# Change application form

Change Car parking layout and second access

Development: Minor Change – Existing Multiple Dwelling At: 11 Marine Parade, Newell (Lot 0 BUP70374)

| <b>Proposal:</b>                                | Change Application – Car Parking  |

Image 1 – Existing and Proposed Site Plan

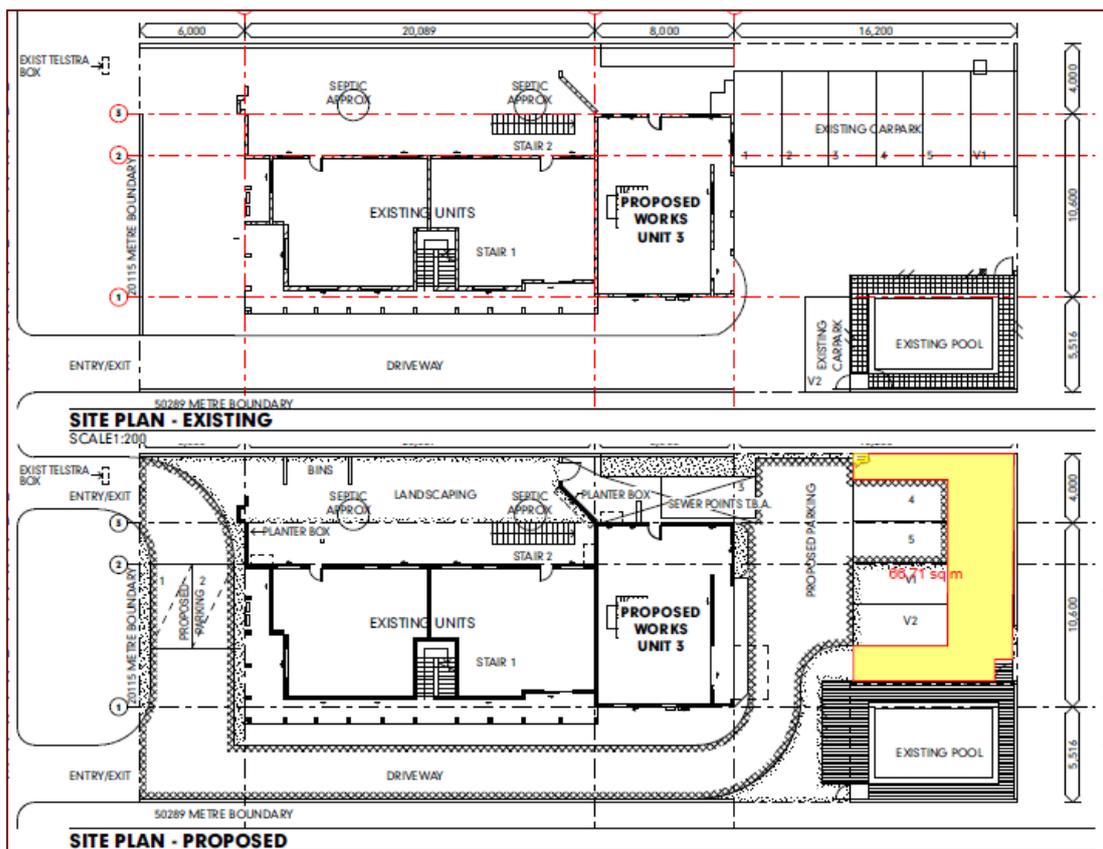
It is proposed to change the development to relocate some of the car parking spaces from the rear of the units to the front of the units and to convert the car parking area into communal recreation space for the residents. The proposal is to relocate two of the on-site car parking spaces from the rear of the development to the front setback area and to reconfigure the rear car parking arrangement such that 5 spaces are located in the rear of the site with one located between the building and the northern side boundary and 4 facing the foreshore.

As part of the proposal the existing on-site effluent disposal would be upgraded to an Advanced Secondary Treatment system from a Primary Treatment System. It has been confirmed by H2O Consultants that the site is able to accommodate the revised car parking arrangement and the effluent disposal.

Drawing Title  
**SITE PLAN**

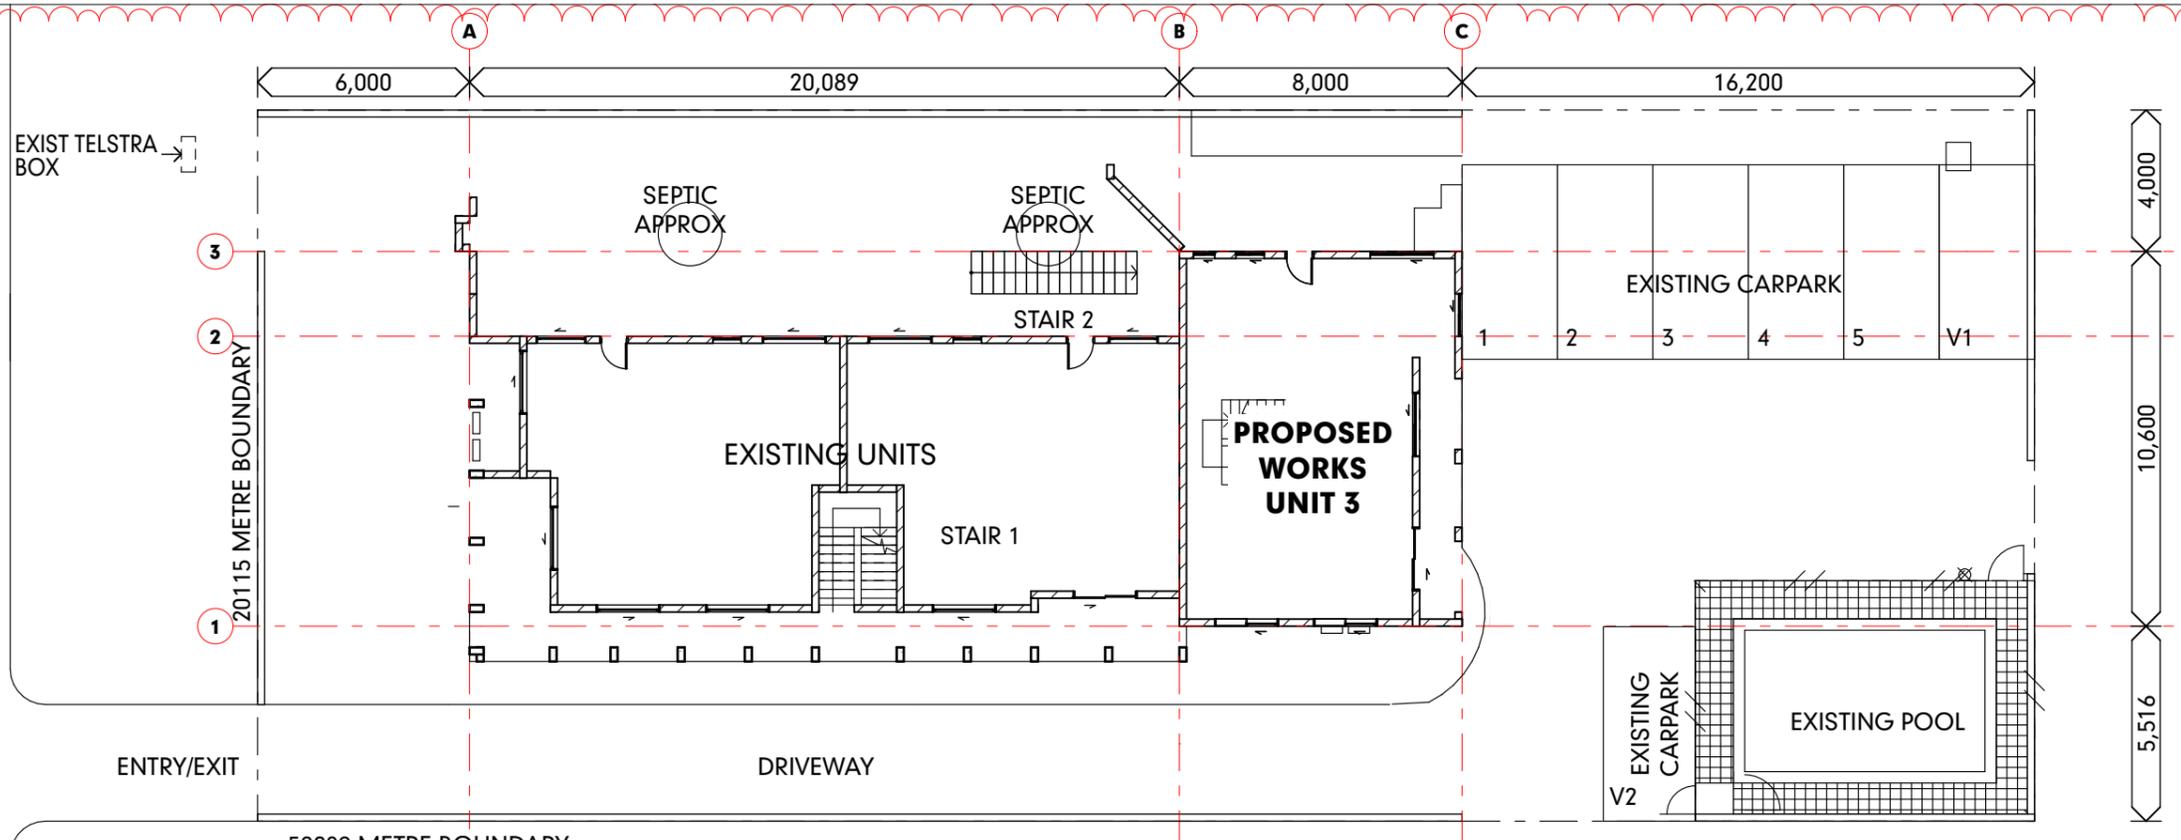
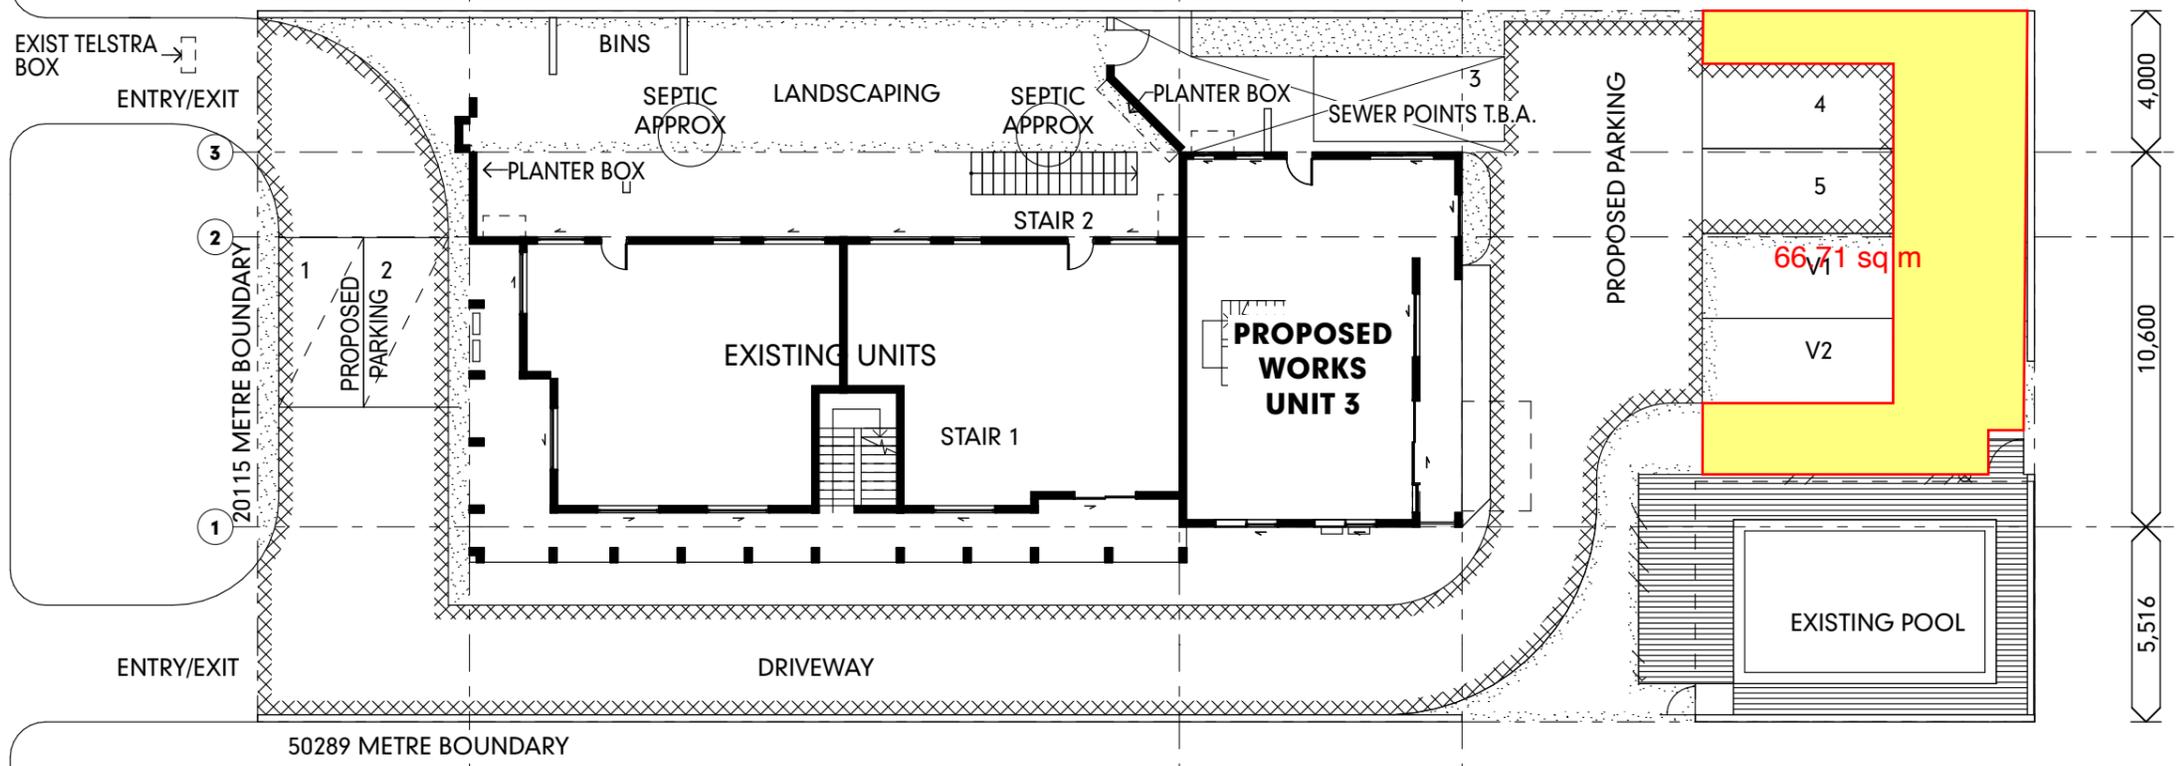
It is proposed to change the development to relocate some of the car parking spaces from the rear of the units to the front of the units and to convert the car parking area into communal recreation space for the residents.

| RevID | ChID  | Change Name                      | Date   |
|-------|-------|----------------------------------|--------|
| A     | Ch-01 | LANDSCAPING & CARPARKING REVISED | 3/9/20 |
